Tunbridge Wells Draft Local Plan
Parish of Capel

Transport Evidence Addendum

Save Capel and Capel Parish Council

Figure 2.4: Residential Islands

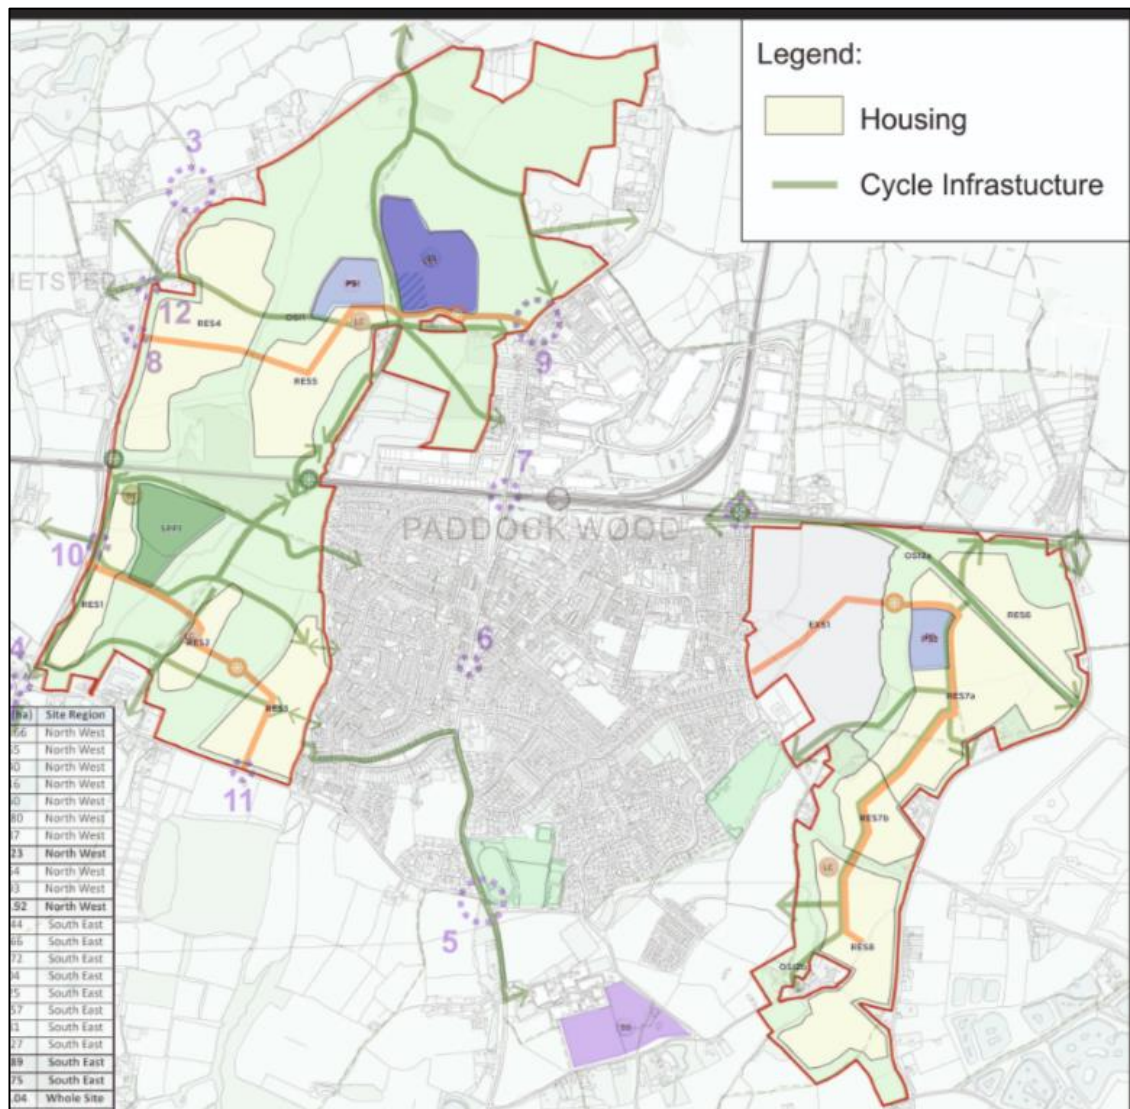
- 2.28 The figure above illustrates the large gaps between residential islands and in particular the remoteness of parcels RES1 and RES2. The remoteness of these parcels is exacerbated by the severance effect of the railway line and indeed they could be considered as remote, isolated stand-alone communities with little in common with the remainder of the draft allocation.

- 2.29 What is also apparent is the significant lengths of active travel infrastructure required to connect these sparsely located islands of development. It is noted that in order to meet current design guidance, the connections will need to be well lit and surfaced, introducing urbanisation into what is otherwise a rural area.

- 2.30 Even in the event that this infrastructure is delivered, it is important to note that people walking or cycling between the islands of development will have to travel on long lengths of way which is not overlooked. This can lead to concerns regarding personal safety and make travelling by these modes, especially in the dark, unattractive. The result being that residents would choose to travel by car.

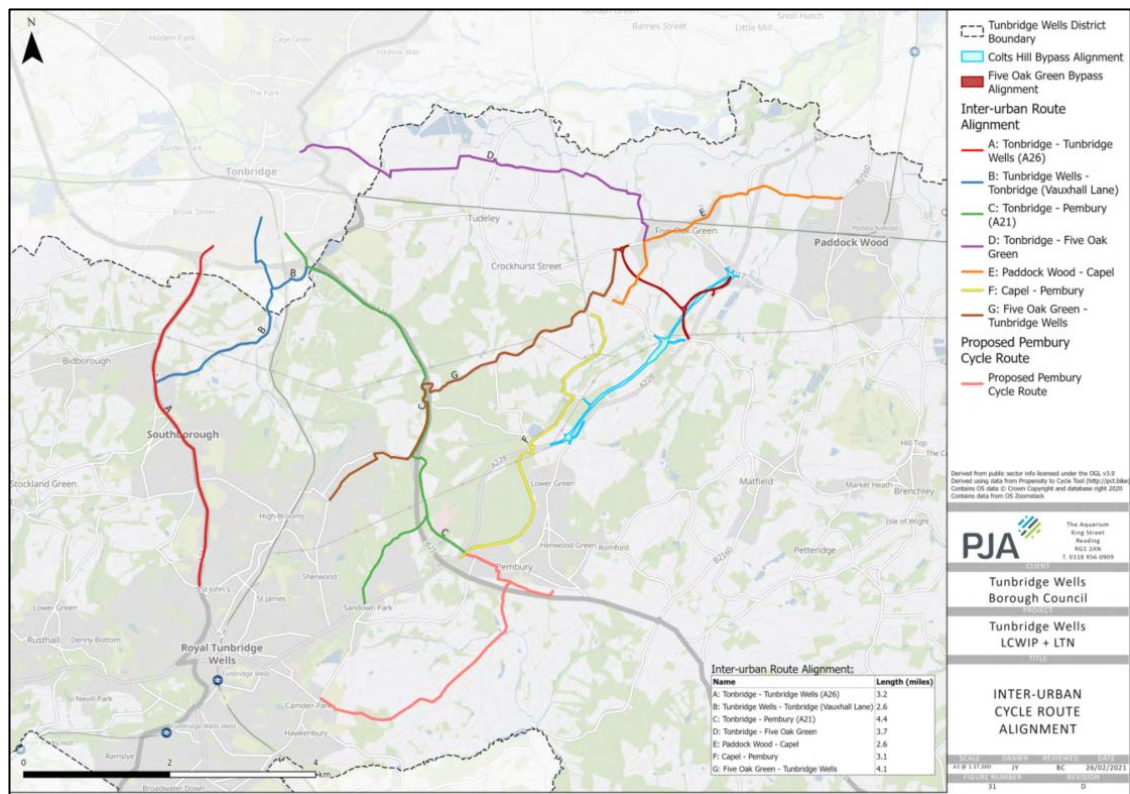
3.22 Notwithstanding the modifications now being promoted by the Council to the draft local plan, it can be immediately seen from the plan above that the Council has wholly failed to consider the implications of the modifications on the cycle strategy which underpins the draft local plan.

3.23 Specifically, attention is drawn to the following:

1. Route E. This route relies on traffic volumes and speeds on the B2017 between Paddock Wood and Five Oak Green reducing as a consequence of traffic diverting to use the Five Oak Green bypass (FOG Bypass) combined with traffic management interventions on the B2017 within Five Oak Green village. The Council now claim that the FOG Bypass is not required to support delivery of the draft Local Plan. The reductions in traffic volumes and speeds on the B2017 in Five Oak Green will therefore not materialise. As concluded by the Council in CD3.115, this will render route E *'generally uncomfortable.....due [to] the lack of dedicated cycling infrastructure combined with narrow road widths and high vehicle speeds'*.

2. The proposed cycle route along the FOG Bypass. In the absence of the FOG Bypass being provided (which the Council now claims is not required), it is assumed that the intention is to provide a stand-alone cycle route along the route of what would have been the FOG Bypass. If this is not the case, then the relevance and voracity of CD3.115 must be questioned and specifically if any of the document can be relied on as evidence supporting the draft Local Plan.

3. The Colt's Hill Bypass is illustrated on the plan in light blue. This is a wholly different scheme to that currently being suggested by the Council in the draft Local Plan.

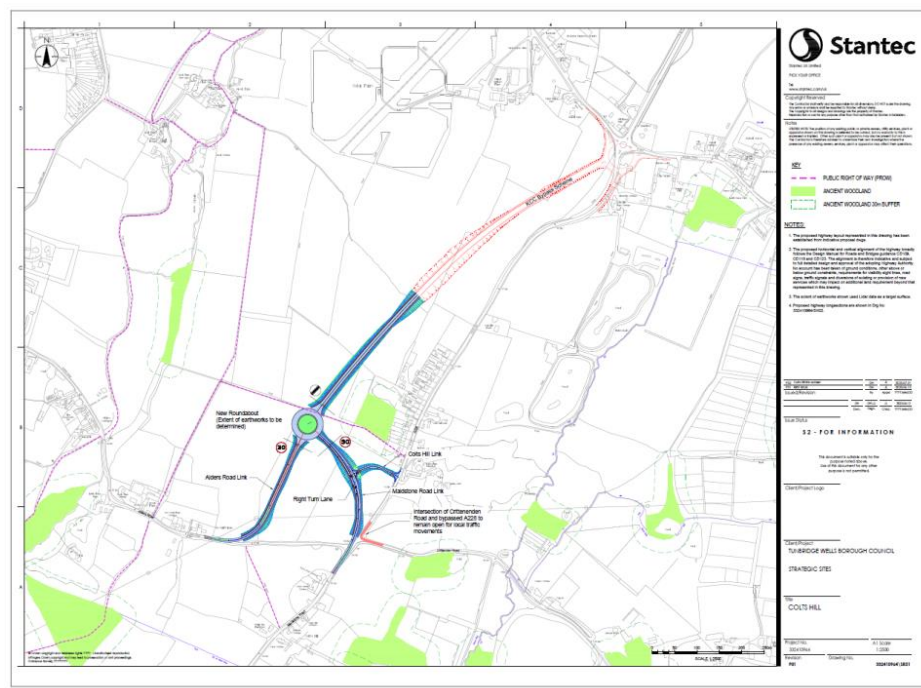
- 6.5 Clarity is sought from the Council regarding what the “Colt’s Hill Bypass” scheme is with regards to the draft Local Plan. Document PS/050 provides the following plan:

- 6.6 The plan above shows the Colt's Hill Bypass as two sections. The southern section is annotated in blue with some detail regarding speed limits and landscaping. The northern section is sketched in red and annotated "KCC Bypass Scheme".

A26/B2017 Roundabout

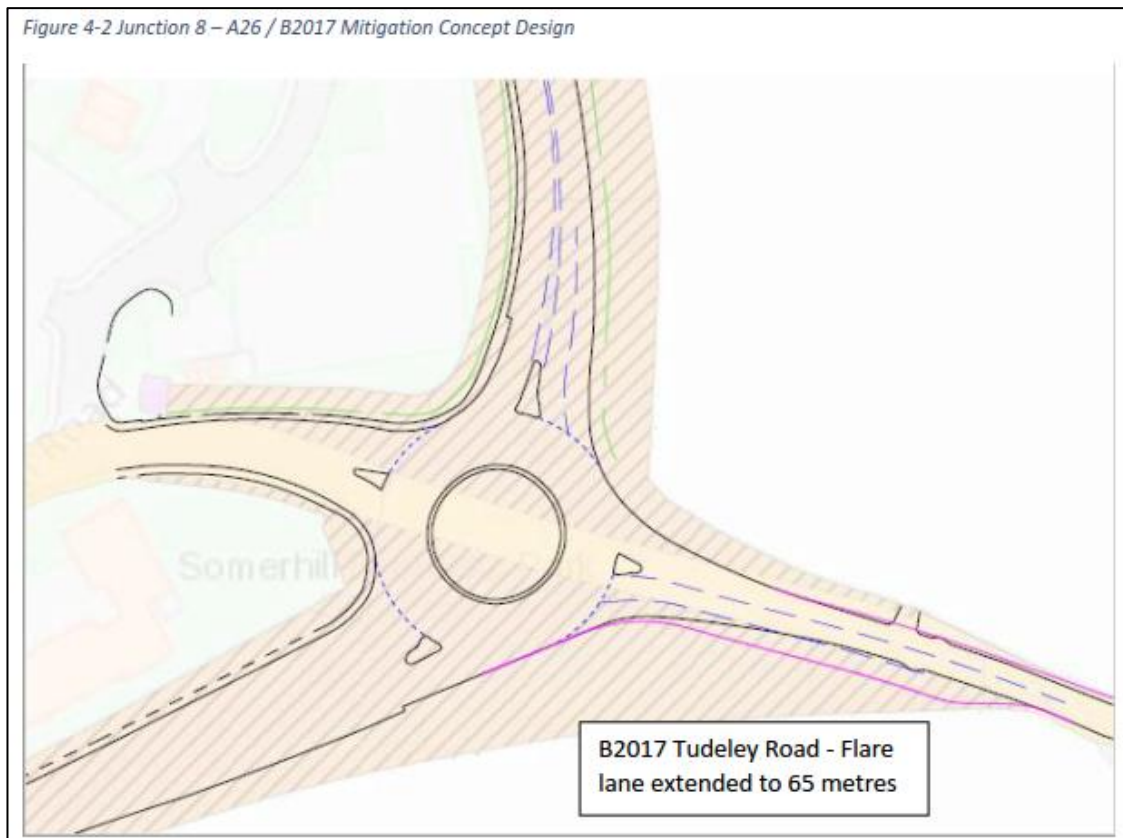
- 6.19 An additional lane on the eastern approach is proposed in this location, as illustrated below.

- 6.20 No checks have been conducted to ensure the design complies with current design guidance or meets safety requirements. It is simply stated that the works are minor in nature and unlikely to result in issues. It should be noted that entry path curvature is a critical safety feature and can change dramatically with relatively small adjustments to entry geometry, an initial design check to ensure compliance with key safety standards should be carried out.
- 6.21 It is further noted that there is existing drainage infrastructure in the area widening is proposed, which can be seen in the image below.

Existing drainage Infrastructure

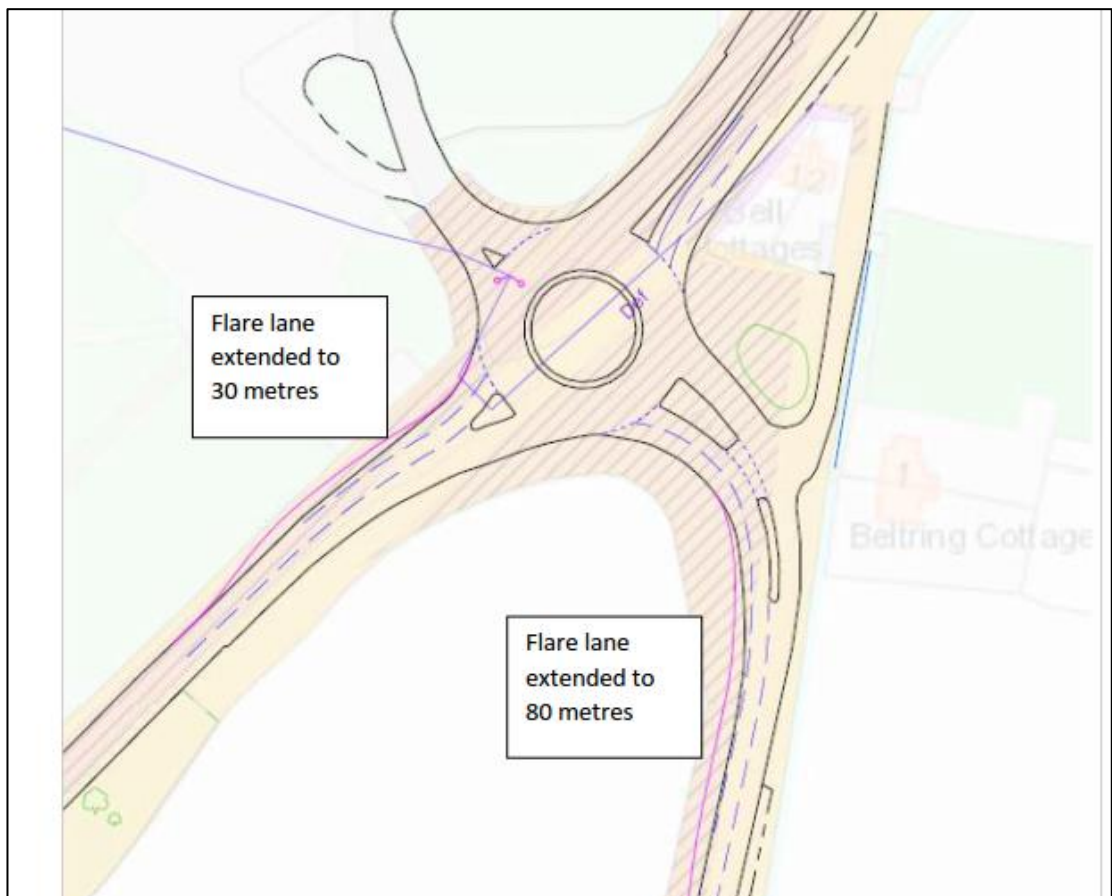
- 6.22 A diversion of the ditch and existing culvert would likely be required. It is unclear whether this is accounted for in the cost estimate provided or whether the Environment Agency would support such works. Information obtained from KCC through an FOI request states that KCC has no record of ditching or maintenance of ditching works in this location. So, while the ditch appears to be within adopted highway, according to KCC it is not their asset. It is therefore unknown who owns and maintains the ditching and if KCC would be able to undertake works to it.

A228/B2017 – Replacement Roundabout

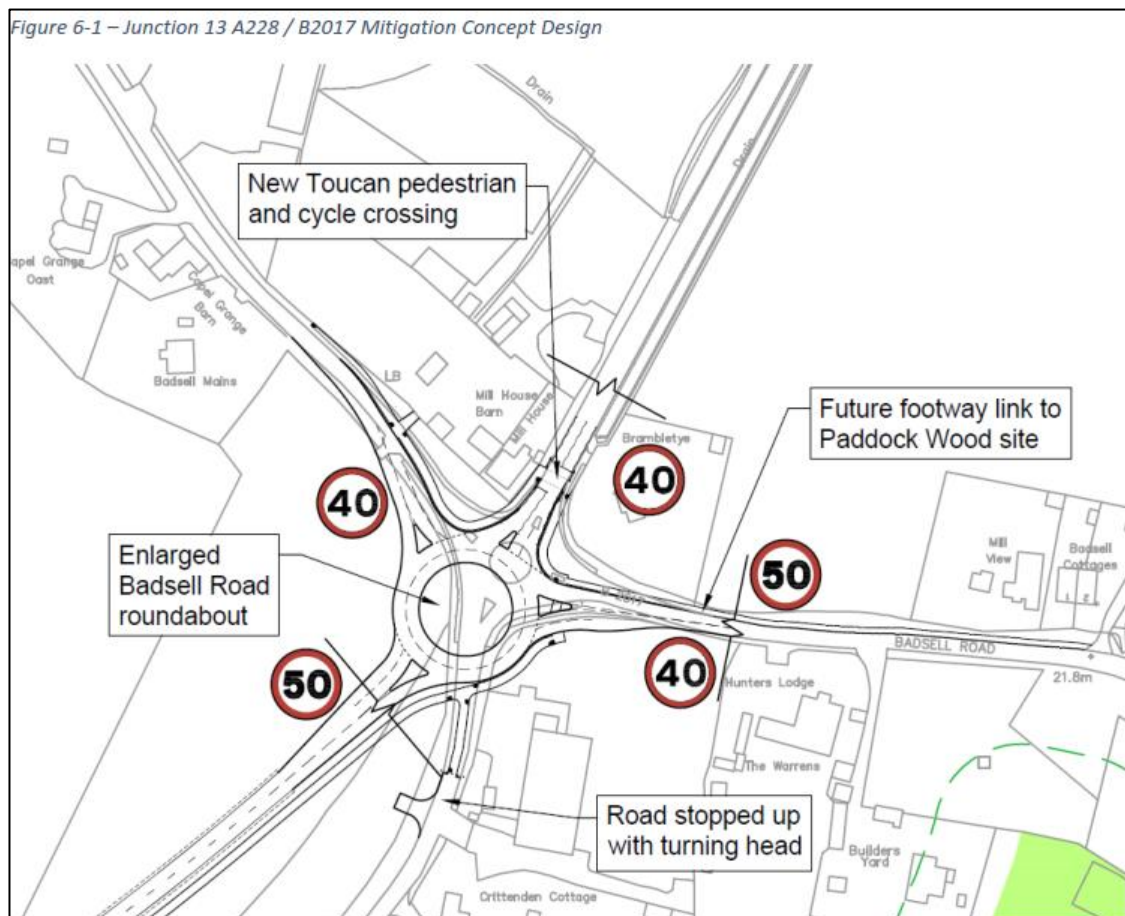
6.26 A replacement roundabout is proposed in this location, joining the Colt’s Hill Bypass to the existing highway network.

6.27 The scheme illustrated above appears to require third party land to deliver, both to accommodate the Colt’s Hill Bypass arm and to the east and northwest. Certainty that control of this land can be established is critical to the success of the plan. Moreover, there is no alternative proposed in the event that this roundabout cannot be delivered or in the event that it remains needed but that the Colt’s Hill Bypass is not delivered.

Figure 8-4 – Kippings Cross Partial Signalised Roundabout Junction

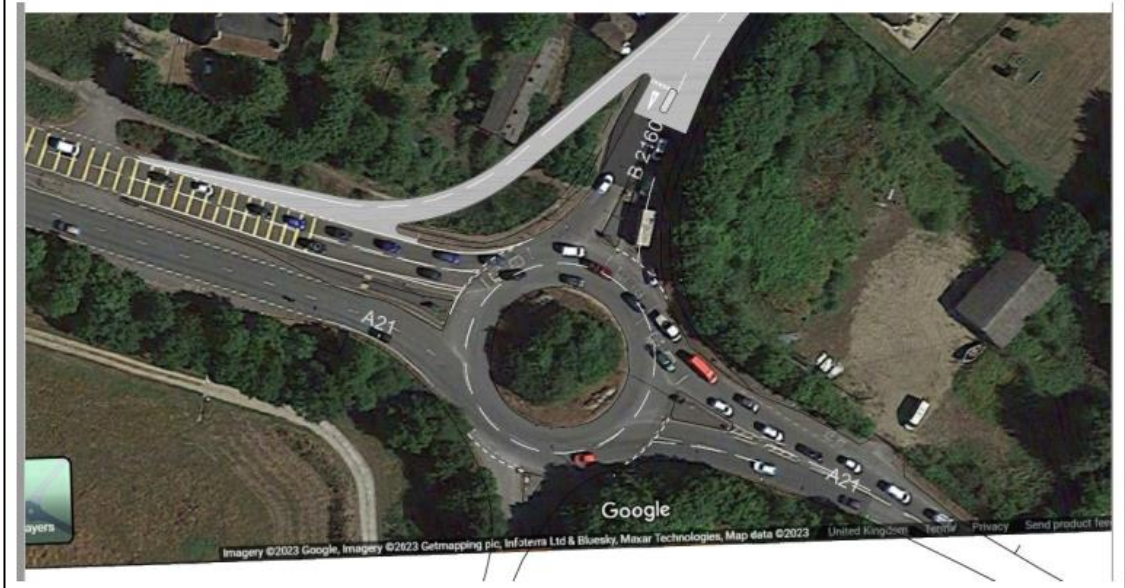
6.29 Two mitigation options have been identified for Kippings Cross. Both require third party land to enable delivery.

6.30 The options shown above differ significantly in terms of the land required and construction cost. It is therefore impossible at this stage to understand, even at a high level, whether either or both can be viably provided.

6.34 For the draft plan to be sound, the proposed policy wording must be revised in order to ensure early delivery of improvements at Kippings Cross, both in terms of a development threshold and delivery mechanism.
